Access Compliance Report

Public Rights-of-Way

Intersection ID: 14508	Main Street: CLANCY_PL	Cross Street: DWIGHTWARE_BV	Location: NW
ADA ID: 5690F0A3CCEA	Ramp Type: Para	Initial Pass/Fail: Fail	Overall Compliance: No
			Severity Score: 13.75

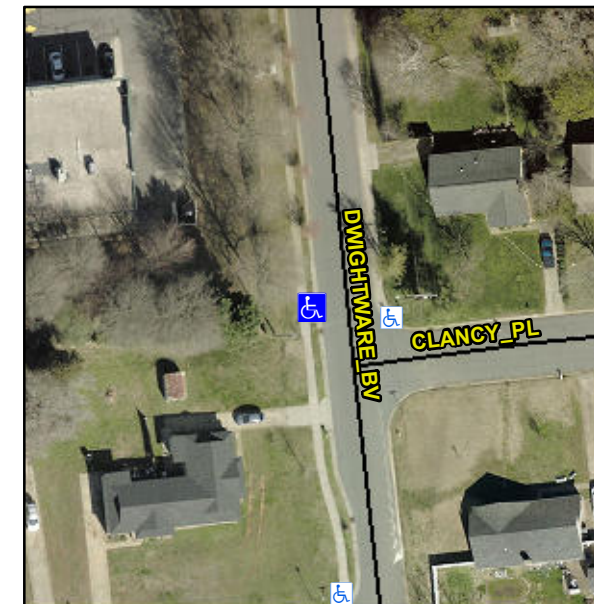
Surveyor Notes:

RT RP < 5%

PROW/ADA:

R304.3.2, R304.5.3

Compliance	Description	Data	Compliance	Description	Data
N/A	Ramp Length LT (in)	64.0	N/A	Ramp Length RT (in)	59.0
Yes	Ramp Width LT (in)	60.0	Yes	Ramp Width RT (in)	60.0
No	Ramp Slope LT (%)	9.9	Yes	Ramp Slope RT (%)	4.8
No	Ramp XSlope LT (%)	2.3	No	Ramp XSlope RT (%)	2.6
N/A	Landing Length (in)	N/A	N/A	DWS Provided?	N/A
N/A	Landing Width (in)	N/A	N/A	DWS Contrast?	N/A
N/A	Landing Slope (%)	N/A	N/A	DWS Length (in)	N/A
N/A	Landing X Slope (%)	N/A	N/A	DWS Full Width?	N/A
N/A	Landing Curb? (Y/N)	N/A	N/A	DWS Offset (in)	N/A
N/A	Shared Landing?	N/A			
N/A	Gutter Ponding?	N/A	N/A	Gutter Slope (%)	N/A
N/A	Gutter Lip Ht (in)	N/A	N/A	Gutter X Slope (%)	N/A
N/A	Painted X Walk1?	No	N/A	Painted X Walk2?	N/A
	X Walk 1 Direction	To E		X Walk 2 Direction	N/A
N/A	X Walk 1 Width (in)	N/A	N/A	X Walk 2 Width (in)	N/A
	X Walk 1 Slope (%)	3.4		X Walk 2 Slope (%)	N/A
	X Walk 1 X Slope (%)	2.1		X Walk 2 X Slope (%)	N/A
N/A	Ramp inside XWalk1?	N/A	N/A	Ramp inside XWalk2?	N/A

Possible Solutions:

Remove & Replace Entire Ramp.
